**APPLICATION FOR RESOURCE CONSENT – SOLAR FARM IN RURAL ZONE,  
MOROA ROAD, GREYTOWN  
PLANNING APPLICATION NO 220103**

**Request for Further Information**

**Resource Consent Application 415 Moroa Road, Greytown (Planning Application No. 220103) – Response to Further Information Request**

Figure 5. Explanation of glare effects. (Source: FNSF, 2022).

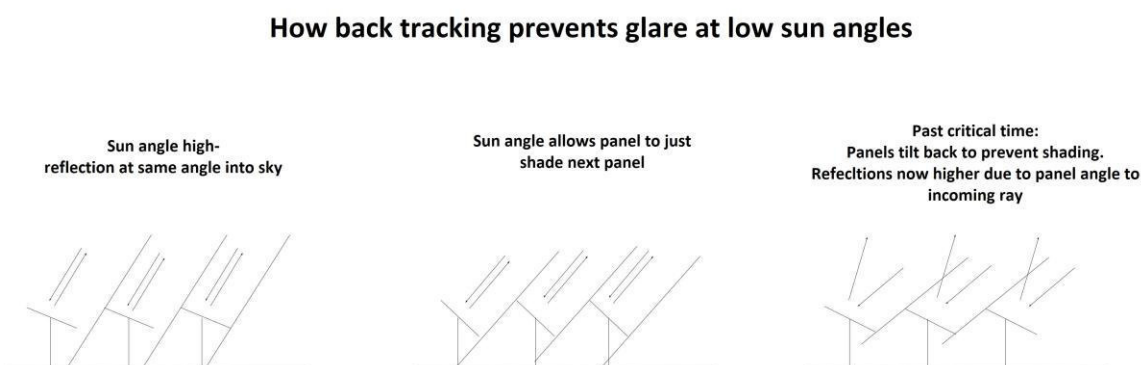
Further information sought on how glare effects are to be mitigated: in particular, further clarification is sought in how backtracking will reduce glare, using clearer larger diagrams.

DRAWING No. ACRA-NZD-GS-GT-001

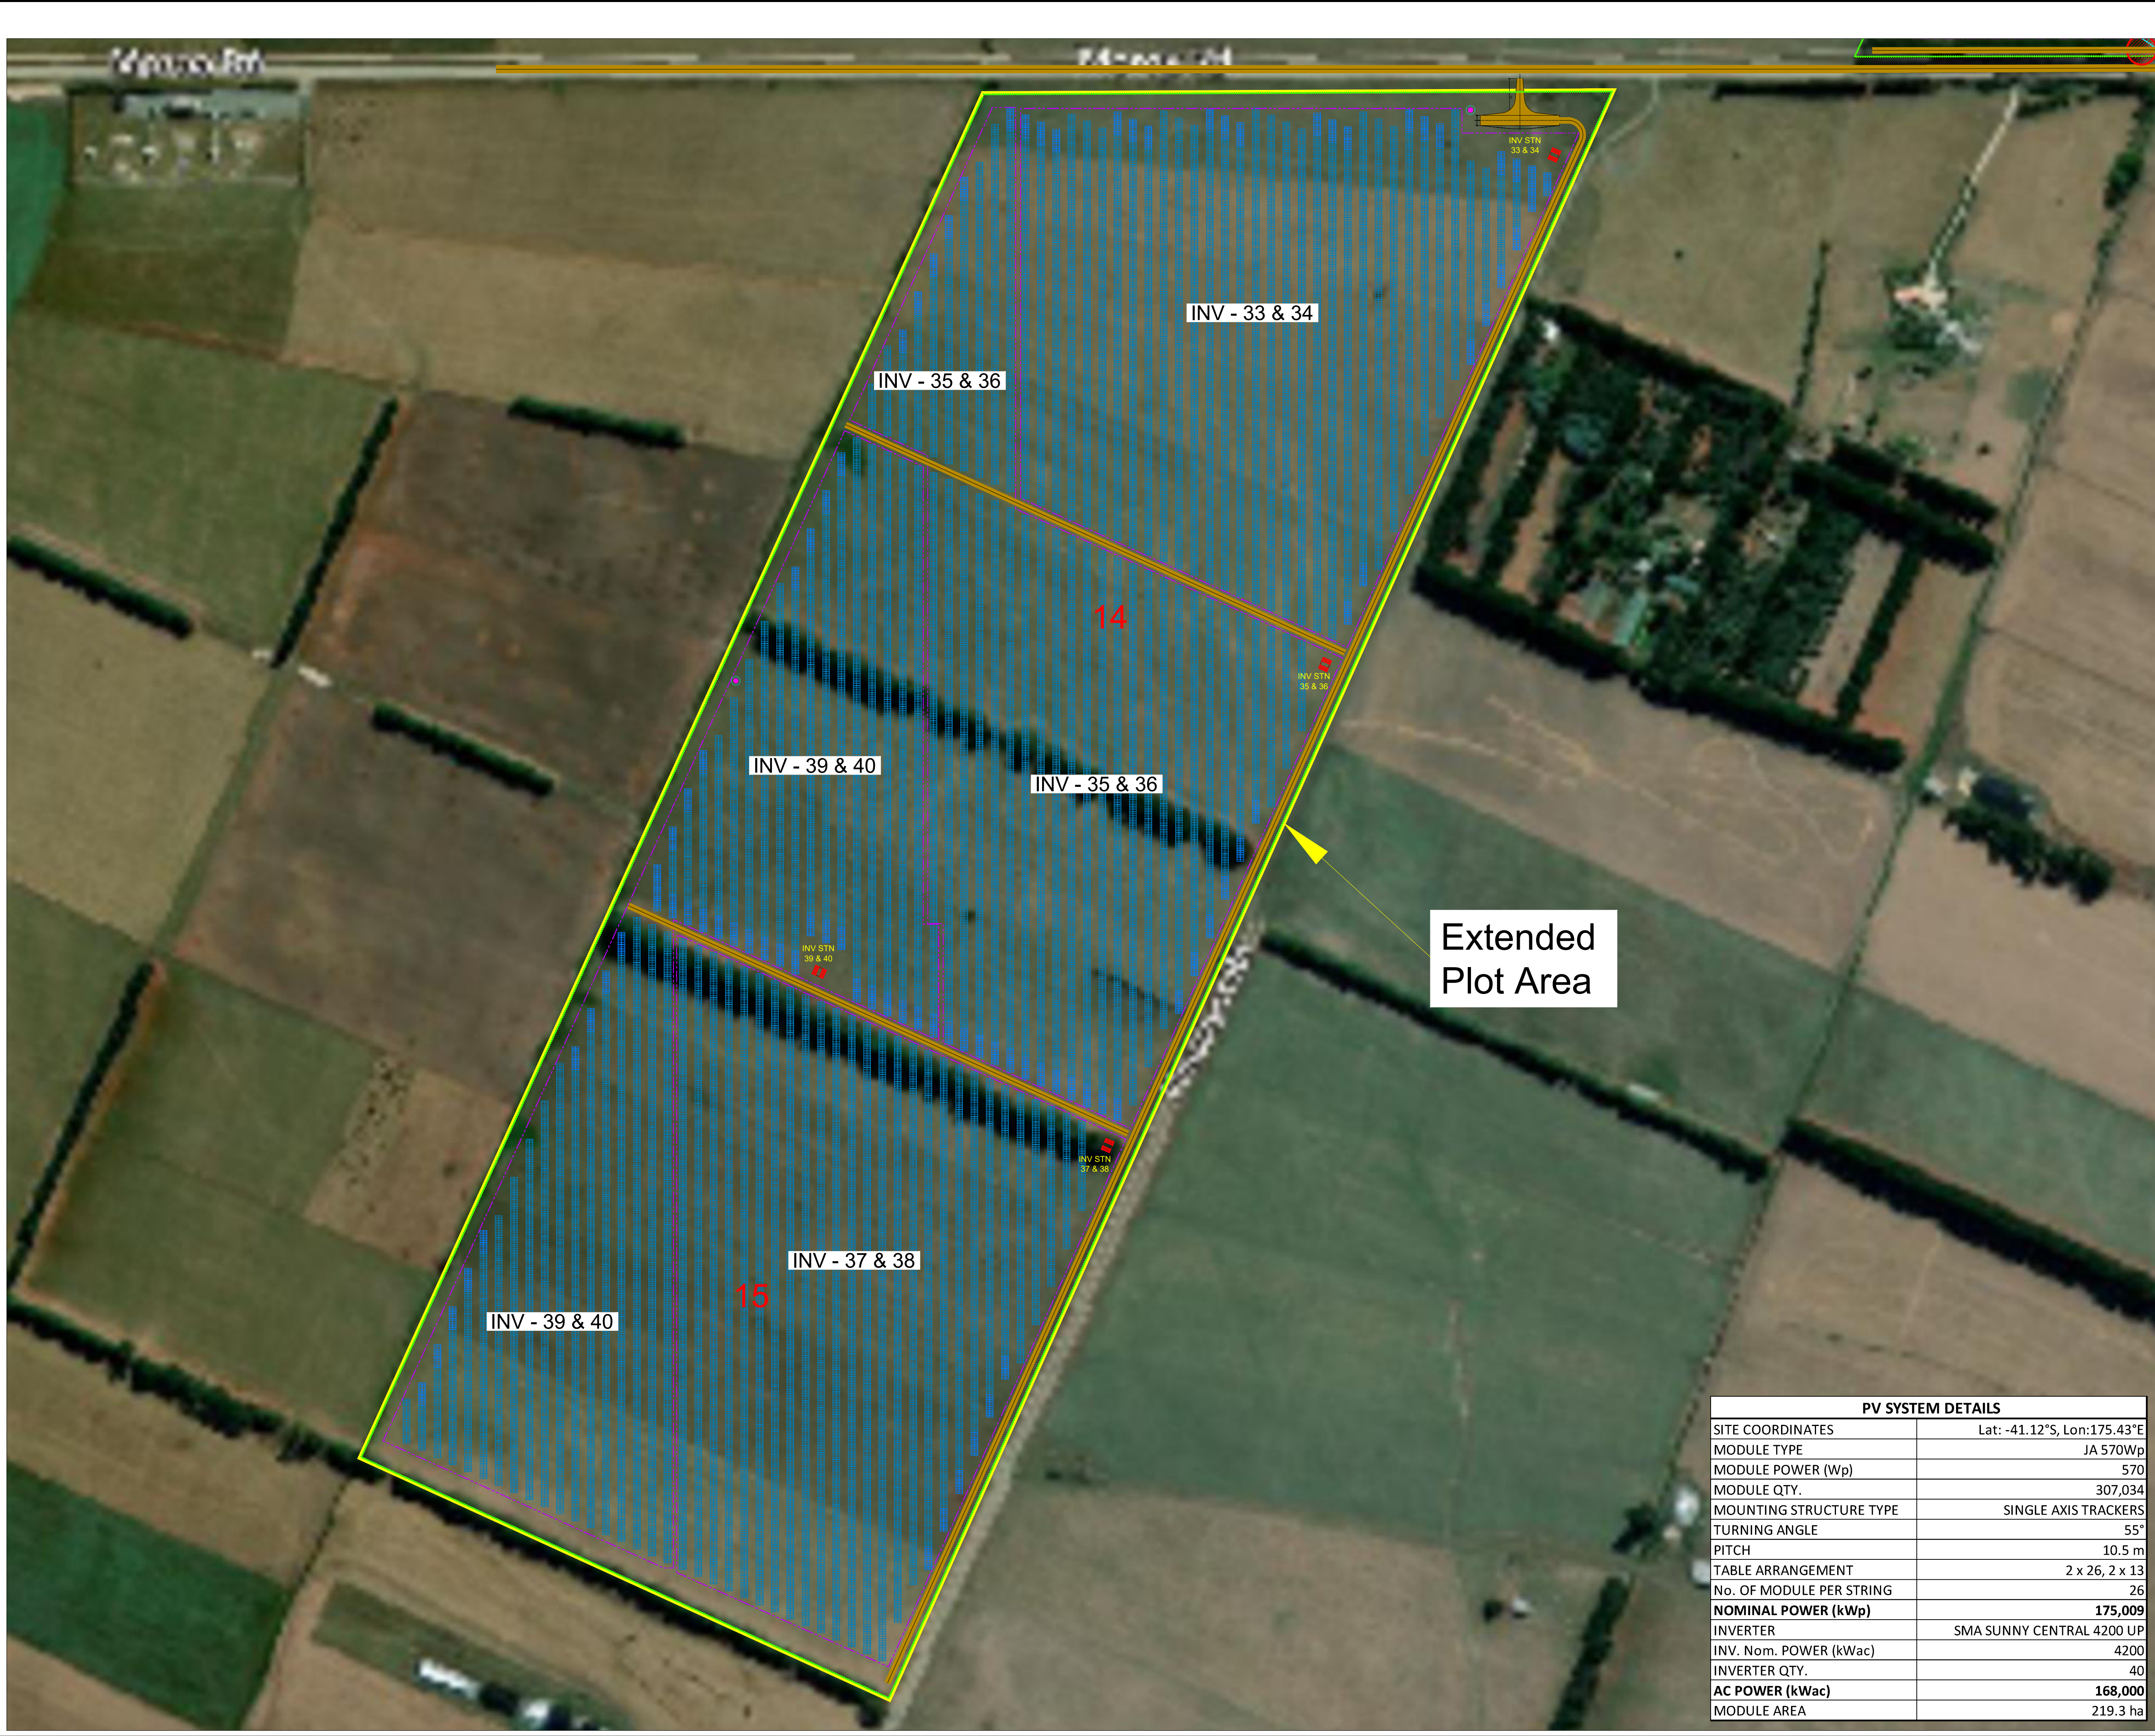
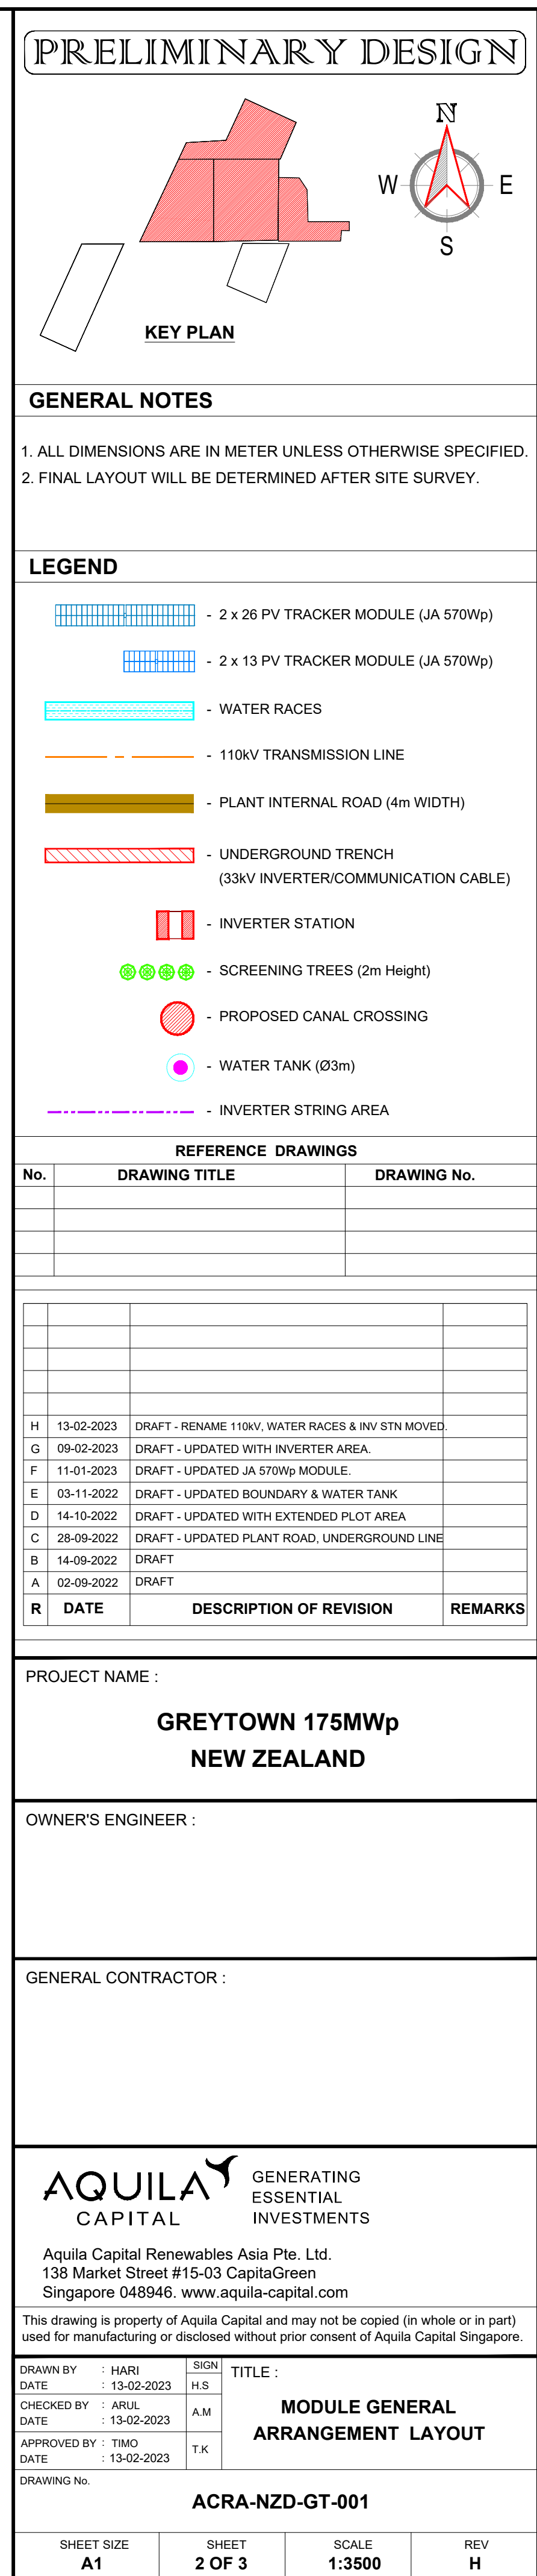
It is stated that all panels and associated structures will be located a minimum of 20m from the centreline of the transmission line. In the Site Plan, two transmission line towers are shown outside the centreline, located close to the arrays to the north. Please clarify.

Clarification as to the number of access points from public roads: in section 3.6 of the AEE, reference is made to three entrances are to be provided to the site, while five entrances are shown on the Site Plan.

*It is stated that all panels and associated structures will be located a minimum of 20m from the centreline of the transmission line. In the Site Plan, two transmission line towers are shown outside the centreline, located close to the arrays to the north. Please clarify.*

*Clarification as to the number of access points from public roads: in section 3.6 of the AEE, reference is made to three entrances are to be provided to the site, while five entrances are shown on the site plan.*

Access to the transmission lines and support structures for Transpower will be maintained at all times and no solar panels or structures will be placed within the 20 m setback corridor. The site plan has been updated to reflect this (refer to **Appendix A**).

Five accessways will be constructed on the site – this is shown on the updated site plan (refer to **Appendix A**). Of these five, two accessways already exist but are not up to the required specifications as outlined in Appendix 5 of the WCDP.
